ENVIRONMENTAL COMMISSION MOTION 20221102-002

Subject: Brodie Oaks Redevelopment PUD, C814-2021-0099

NAME & NUMBER OF PROJECT: Brodie Oaks Redevelopment PUD C814-2021-0099

Brodie Oaks Redevelopment PUD

Exhibit G: Grading Plan

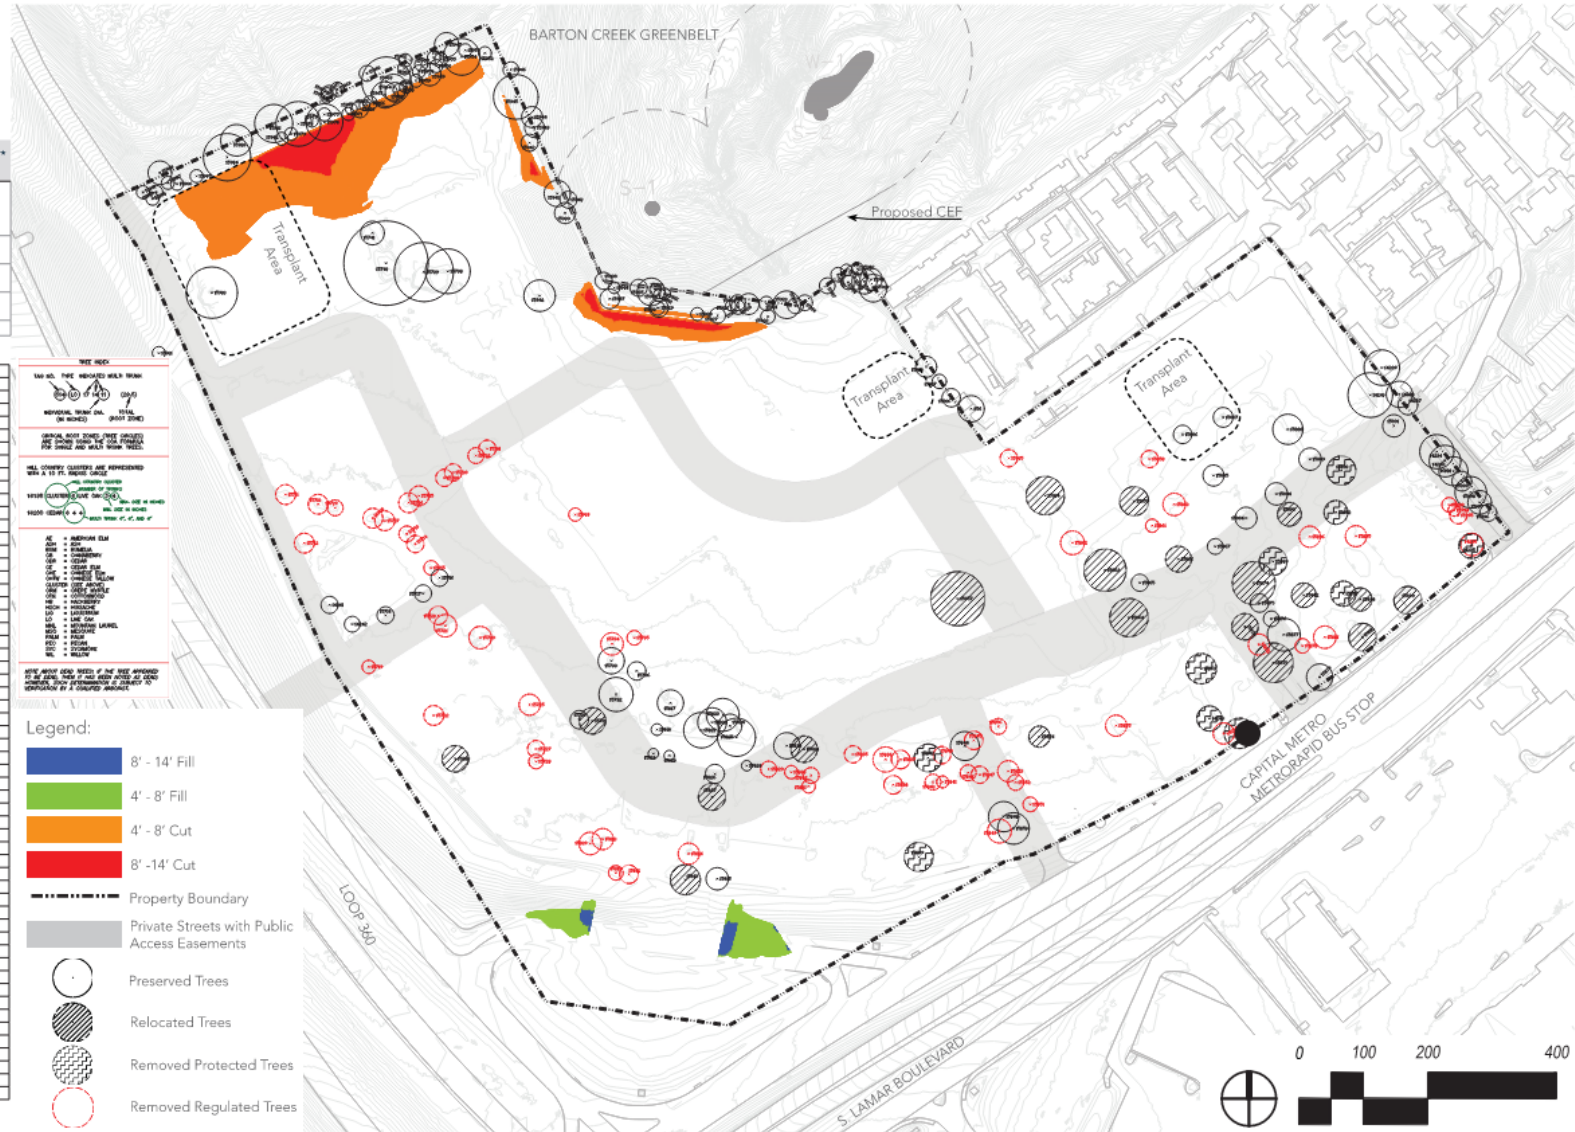
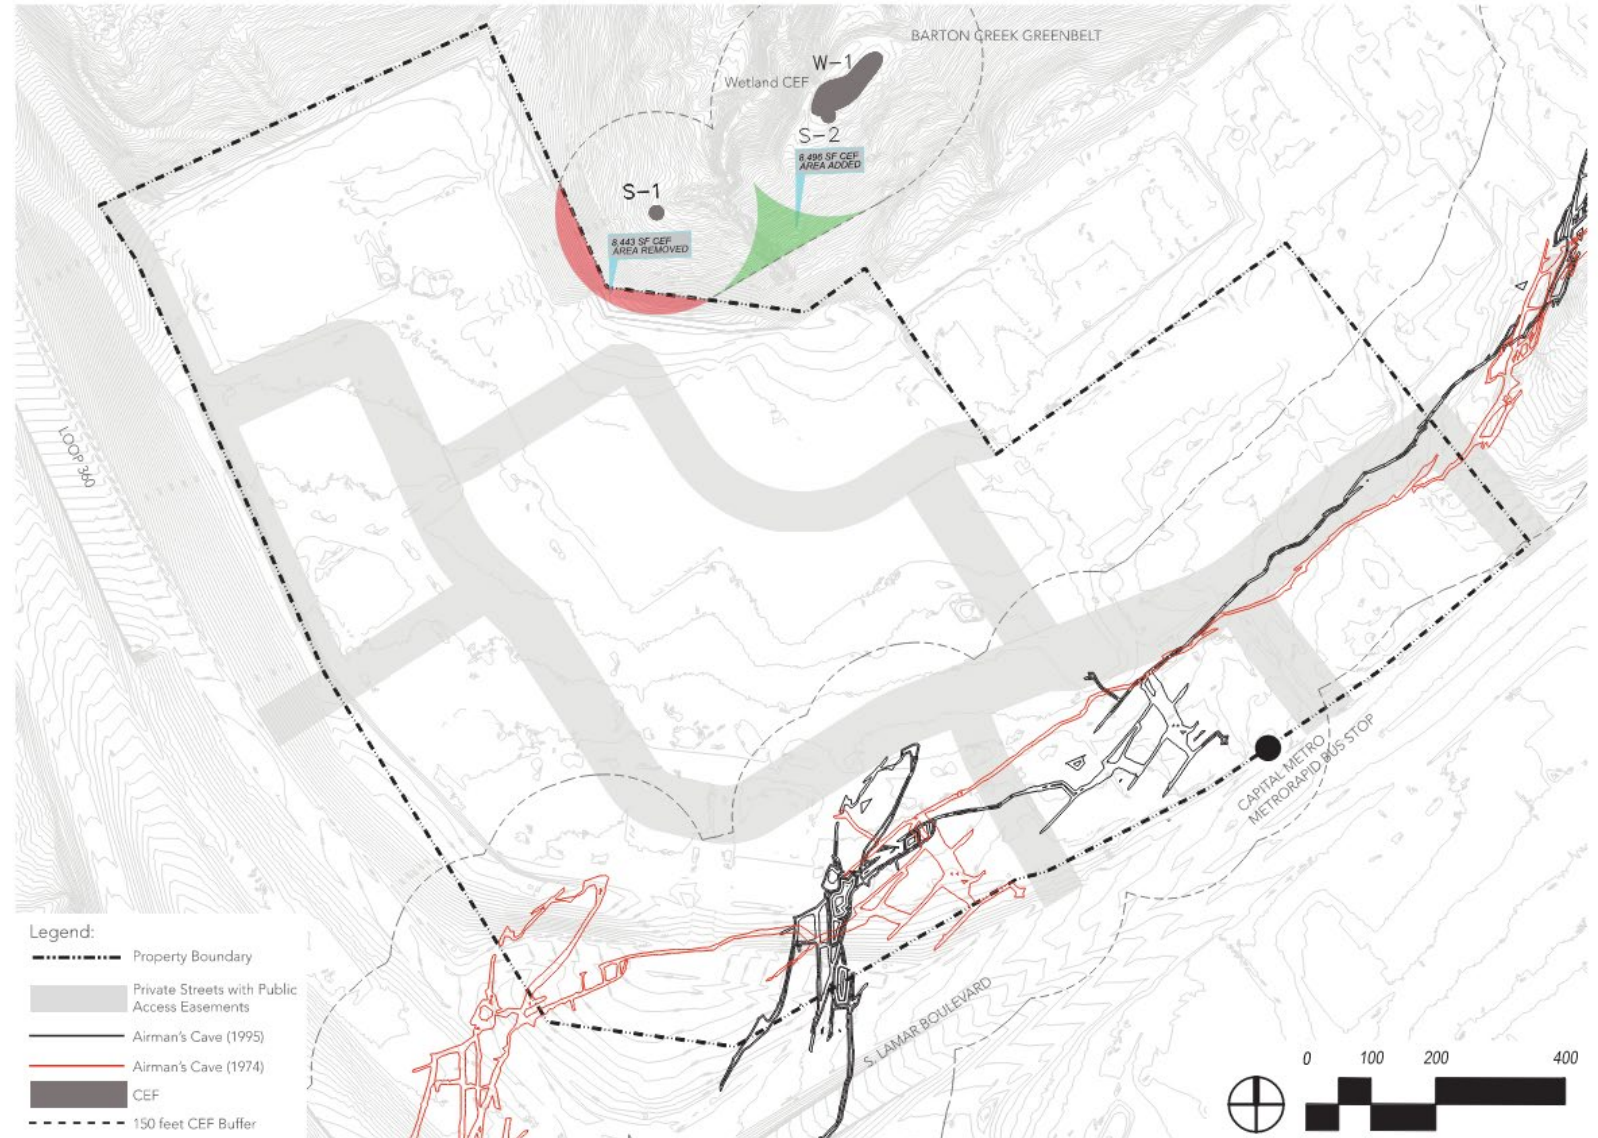
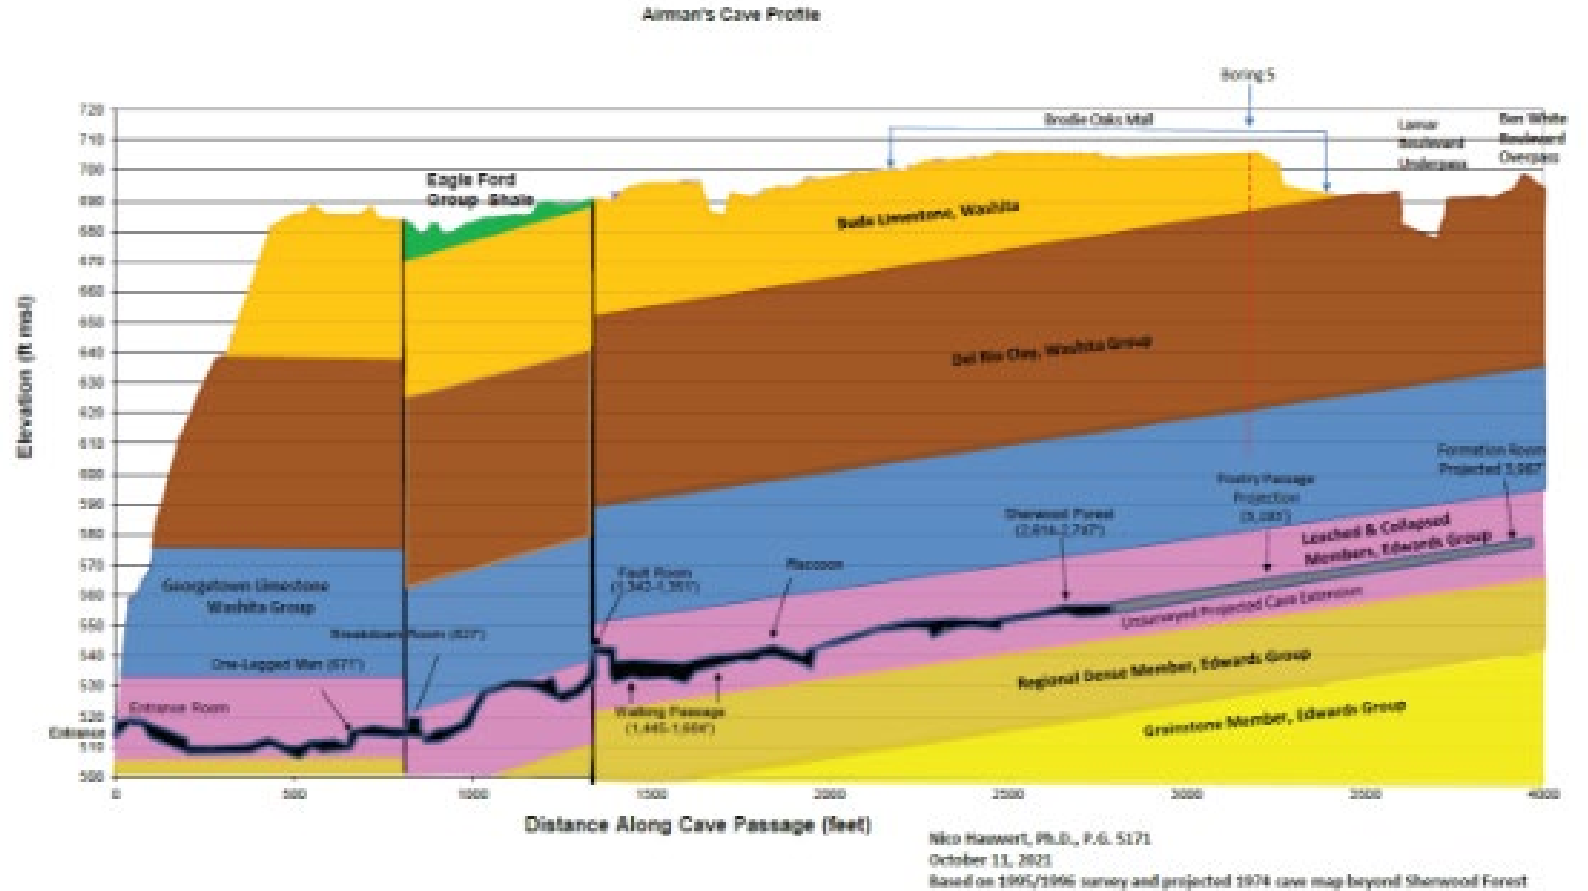
- 25-8-341 shall be modified to allow cut not to exceed a maximum of fourteen (14) feet as indicated on Exhibit G.
- 25-8-342 shall be modified to allow fill not to exceed a maximum of fourteen (14) feet as indicated on Exhibit G.
- 25-8-281 shall be modified to allow encroachment into CEFs as indicated on Exhibit F.

Exhibit F: Environment

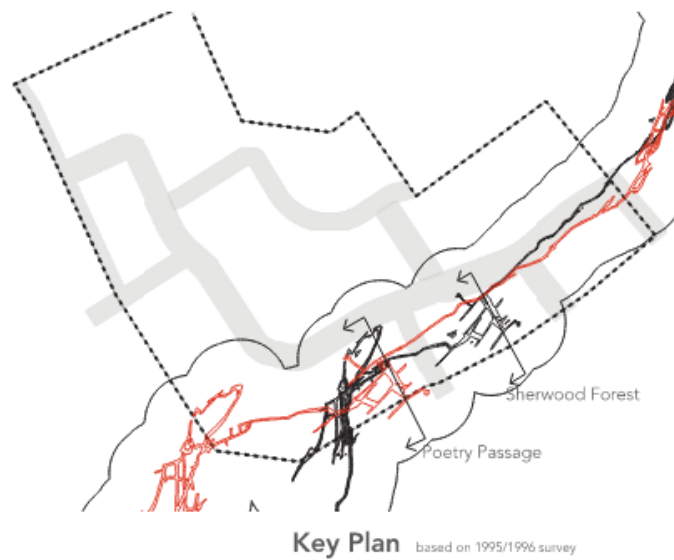
1. Modify CEF setback for S-1/S-2
2. Impact to Airman's Cave CEF setback is limited of up to 80' with conditions
3. Protective fencing for CEFs

Exhibit F: Water Quality

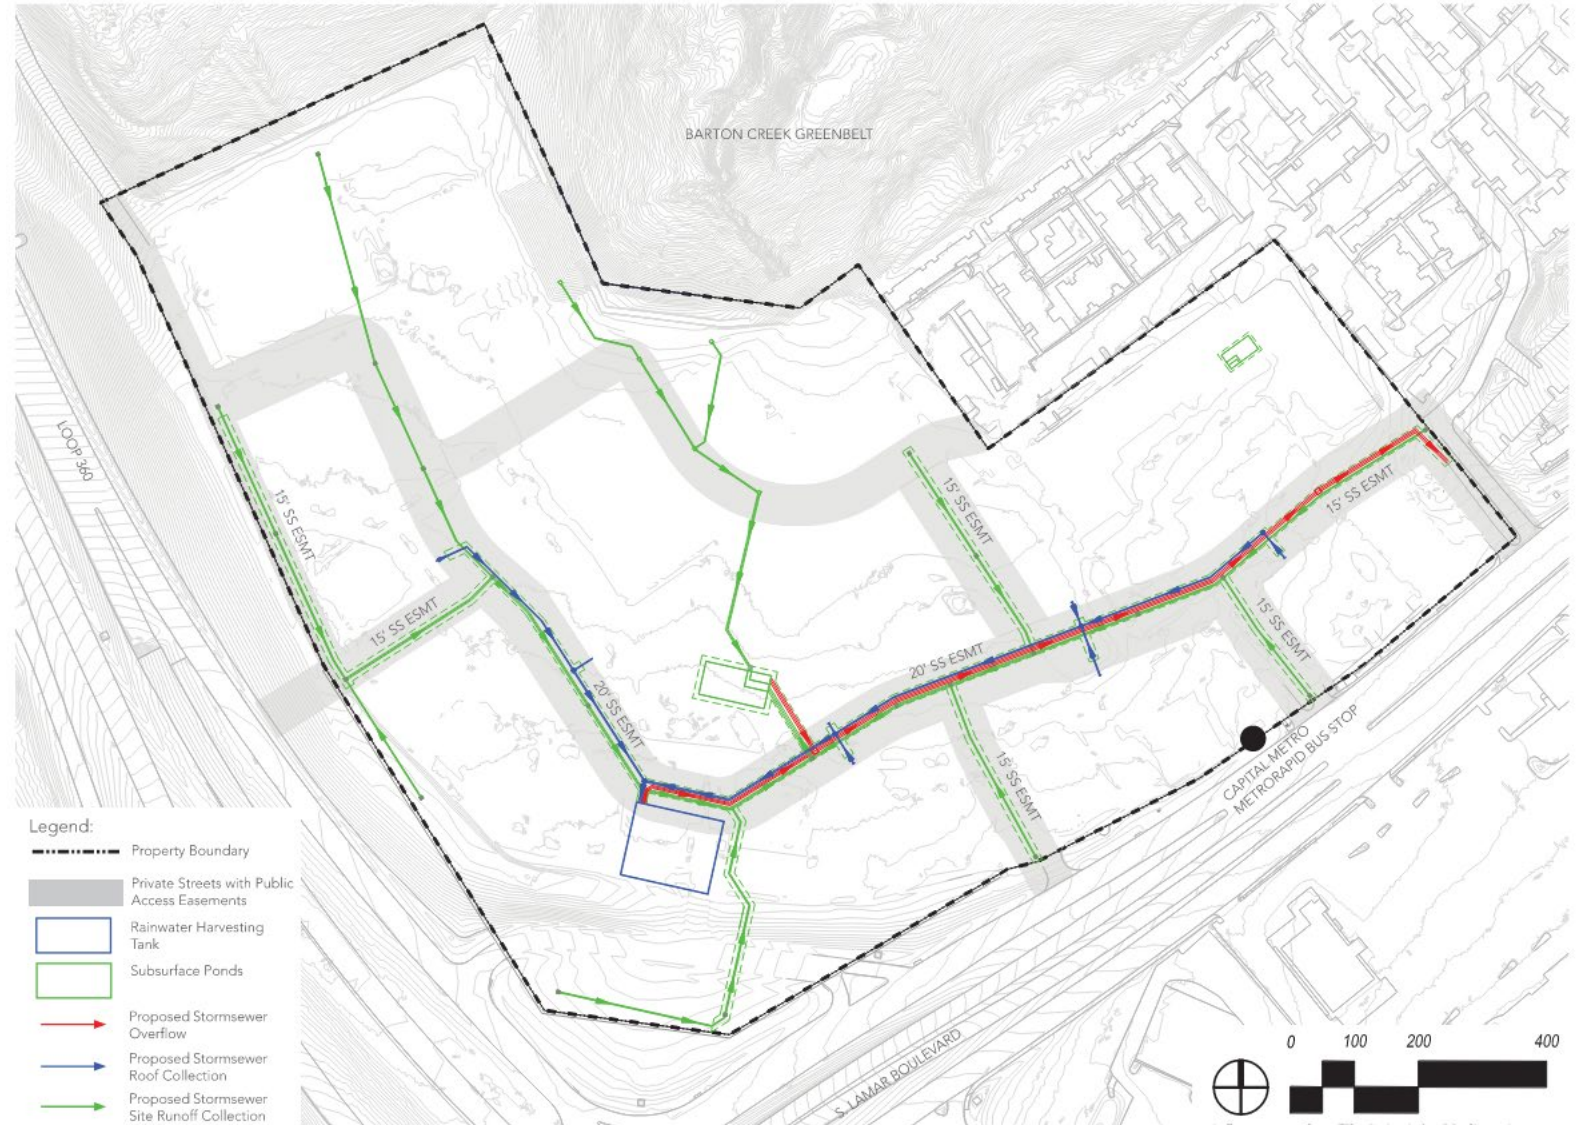
1. Brodie PUD will comply with SOS with subgrade ponds for retention/reirrigation system and rainwater harvesting with beneficial reuse
2. Infiltration testing
3. Trenching > 5' will be inspected by geologist
